FIRST DRAFT MINUTES

February 18, 2021 Standards Committee Meeting

RE: Minutes from the February 18, 2021 Standards Committee Meeting

E 801-TCTC-09 MAINTENANCE OF TRAFFIC FOR RPM REFLECTOR REPLACEMENT (WITH MARKUPS)

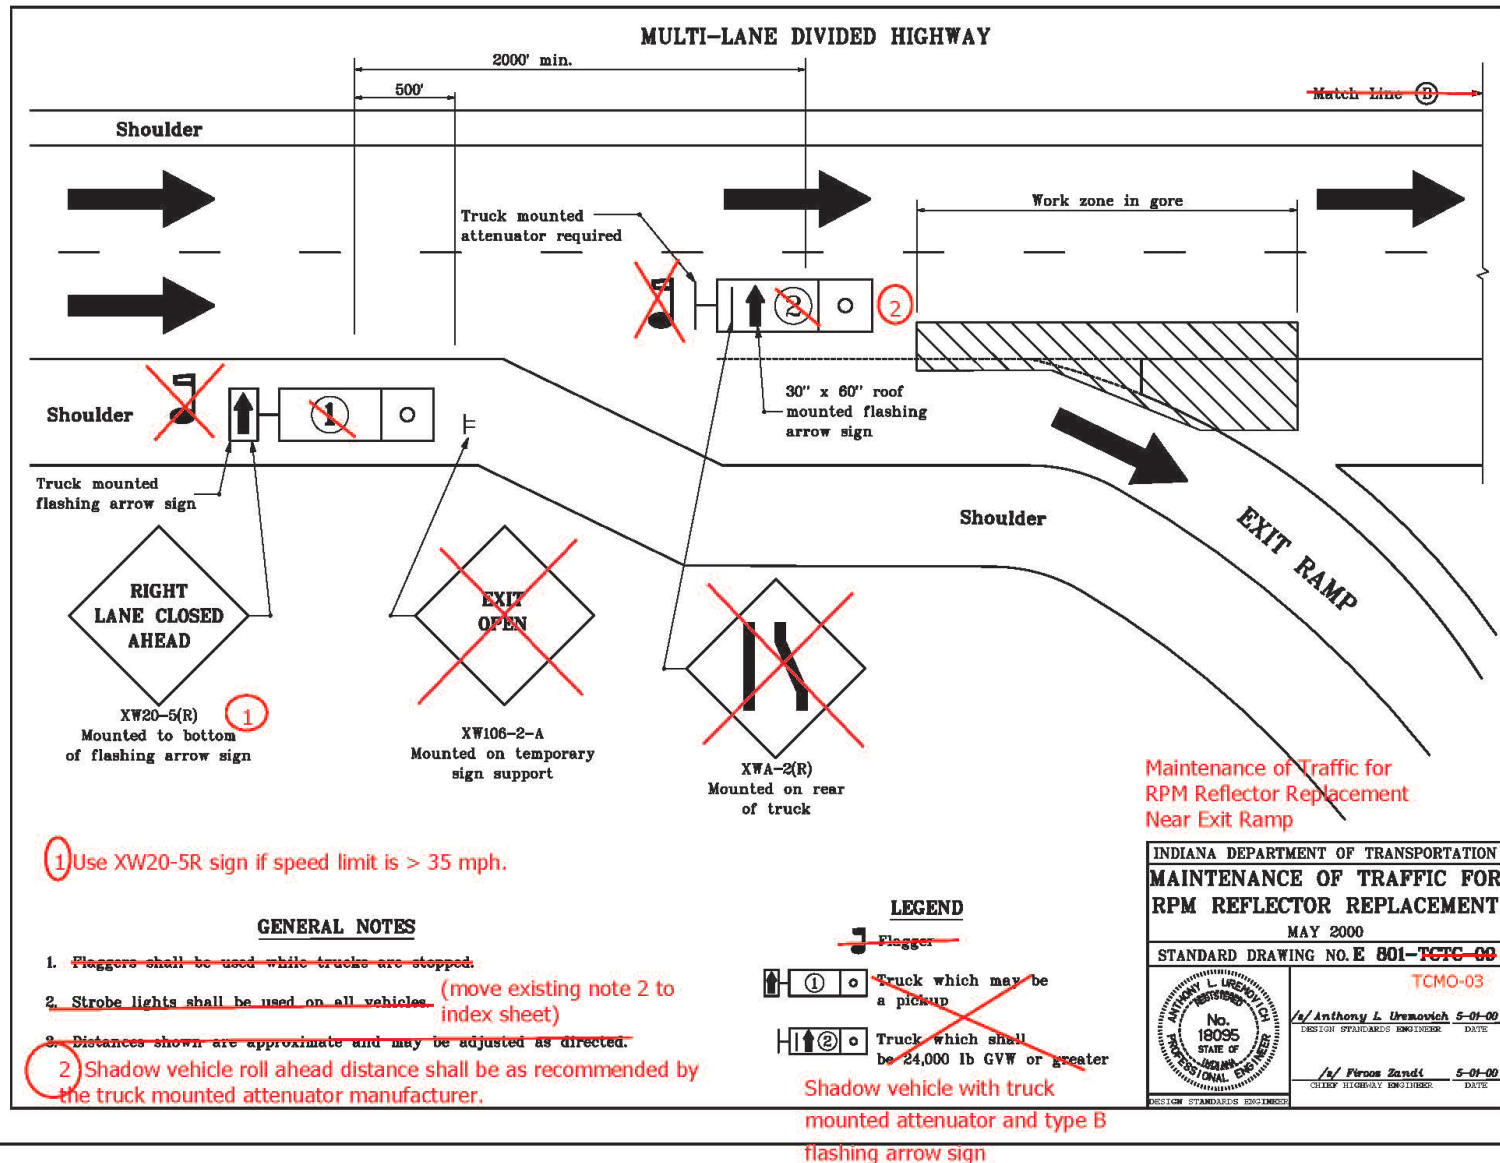
Move to New Series on Traffic Control for Mobile Operations

E 801-TCTC-10 MAINTENANCE OF TRAFFIC FOR RPM REFLECTOR REPLACEMENT (WITH MARKUPS)

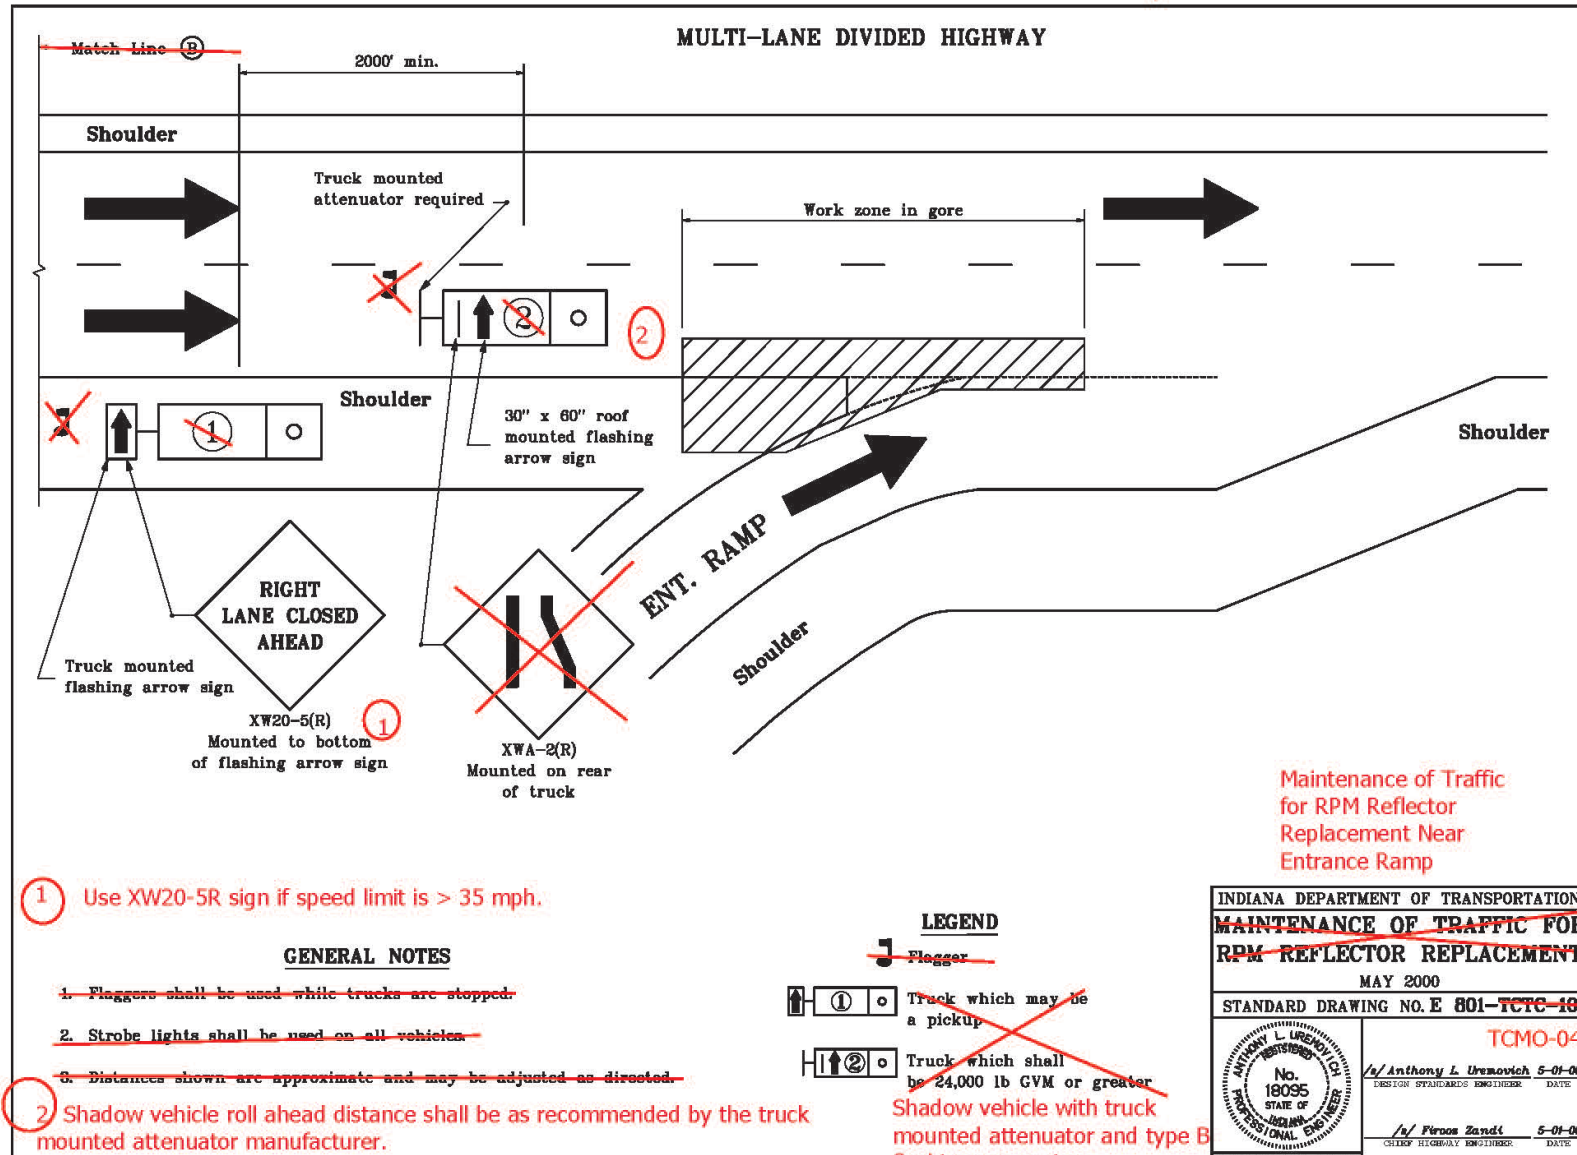
Move to new series on Traffic Control for Mobile Operations
